# UNITED STATES PATENT AND TRADEMARK OFFICE

APPLICATION NO.	FILING DATE	FIRST NAMED INVENTOR	ATTORNEY DOCKET NO.	CONFIRMATION NO.
10/500,583	06/29/2004	Jan Webjorn	P/4447-3 PCT	5248

**Office Action Summary**

A. J. DEL BUONO  
BALANCED FACE FLANGE  
Filed Nov. 8, 1957

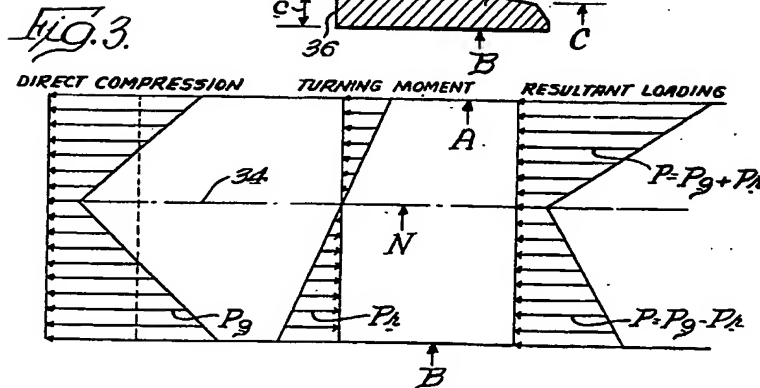
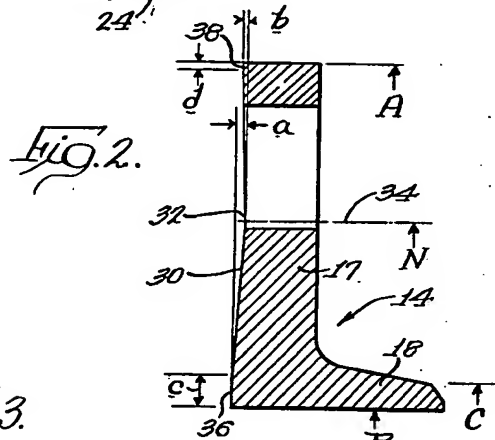
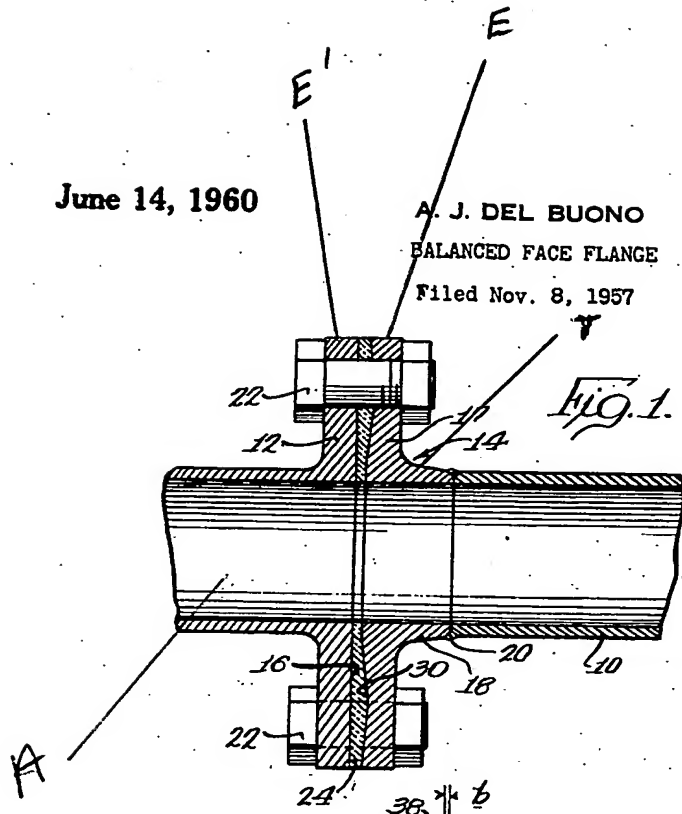
In regard to claim 1: Buono discloses a flanged member (14) (Figs. 1-3) intended to included as a first component in a flange comprising a first component (14) in a flanged joint having a first flanged end (E) with a first end surface (30) intended to be assembled together with a corresponding end surface (16) of a flanged end (E') (see attachment) on another, a second flanged member (12) in the flanged joint, the first end surface (30), in unstressed condition is slightly concave in the radial direction over at least a part of the extension thereof in the radial direction.

In regard to claim 6: Buono discloses (Figs. 1-3) that further comprising an internal through axial opening (A) (see attachment), the first end surfaces (30) having an innermost abutment point against the corresponding end surface (16) of the second flanged member (12), which abutment point is situated farthest in the radial direction at the opening (A), the concavity of the first end surface (30) extending all the way in to the abutment point.

In regard to claim 9: Buono discloses (Fig. 2) wherein the first end surface (30) is inclined in the radial direction out-wards and away from a conceived opposite end surface (16).

In regard to claim 10: Buono discloses (Fig. 1) wherein at least a part of a transition area (T) (see attachment), between the surface of the flange directed away from the end surface (30) and a part of the flanged member that is substantially parallel to a longitudinal axis of the member, is shaped as a substantially elliptical area.
